Class Rule Change

International 29er Class Association

Amendment One

C.10.3 MAINSAIL

MAINSAIL DIAGRAM

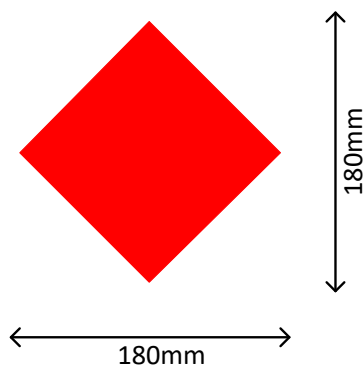
- (vi) Mainsails used by all women crews shall carry a red rhombus (length of diagonals –maximum 190mm, minimum 170mm) just below the 2nd batten from the top of the mainsail and shall be placed on both sides of the sail, superimposed, above the Country code, minimum 60mm from the leach. The Notice of Race may change this rule.
